Re: Summary of Bi-weekly Inspection of Lost Creek ISR LLC's Permit 788

Wyoming Department of Environmental Quality (WDEQ)- Land Quality Division (LQD)
Inspection Memorandum

File: Lost Creek ISR, LLC – Permit 788

Subject: Bi-weekly Site Inspection

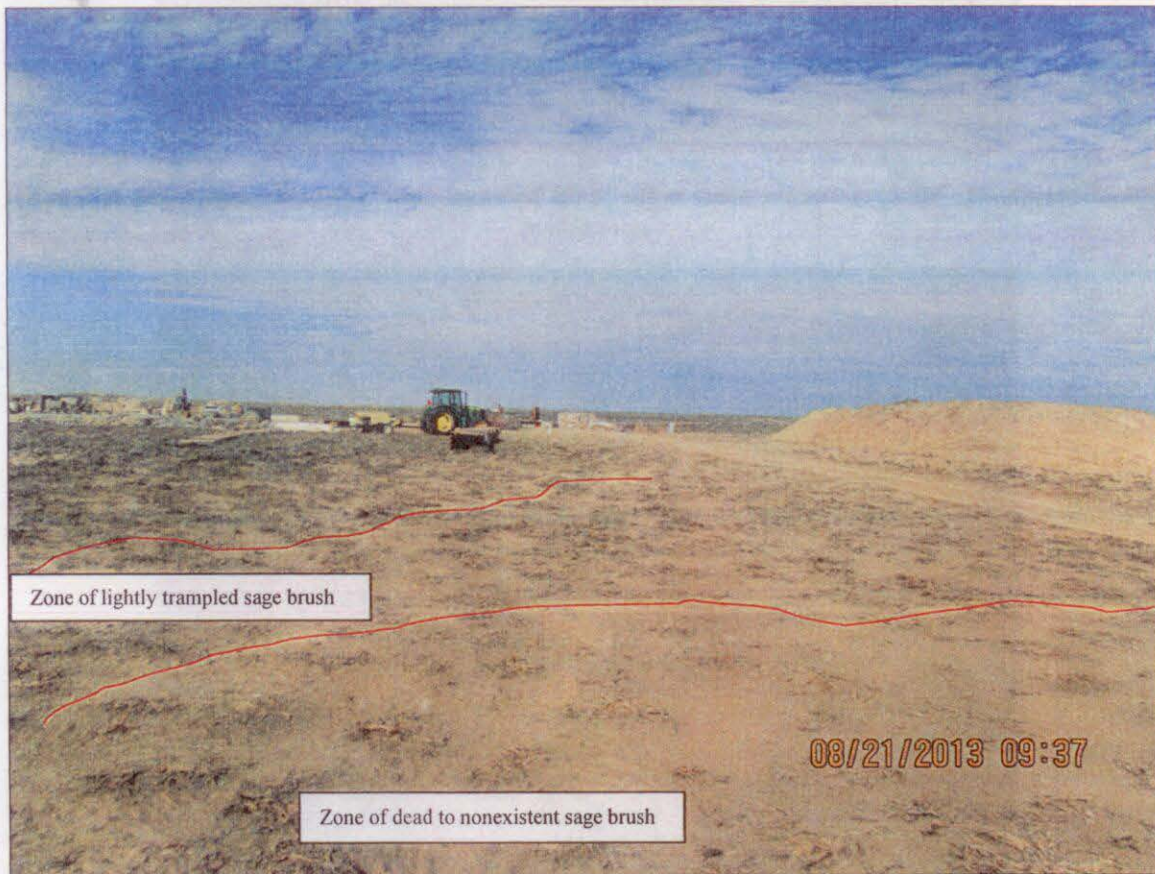
The ground underneath where equipment had been stored in the “field laydown area” displayed varying degrees of dead vegetation, trampling, and plant/soil compaction. In some areas, the sage brush appeared to be non-existent or dead. While in other areas, the sage brush was slightly trampled but still alive. Mr. Stonaker and Ms. Bautz agreed that the areas with dead to non-existent sage brush would be scarified and seeded this fall; while the areas with lightly trampled but still living sage brush would merely be seeded via broadcast methods and hand raking. In both types of ground (dead sage and living sage) the grasses were essentially destroyed.

Photo Number 1: This depicts a portion of the “field laydown area” north of MU1, from which equipment has been removed. The area of dead to nonexistent sage brush can be seen in the foreground of this photo. Then there is a transition into an area of lightly trampled sage brush within the two red lines. Beyond that area is intact sage brush. This view is looking west.

To that end, LCI personnel have removed the majority of equipment from the “field laydown area” and relocated it to the DDW-4 drill pad. In turn, the driller’s equipment that had been staged at DDW-4 was relocated to the DDW-3 drill pad. Only a minor amount of equipment needs to be removed from the “field laydown area” before fall 2013 reclamation.
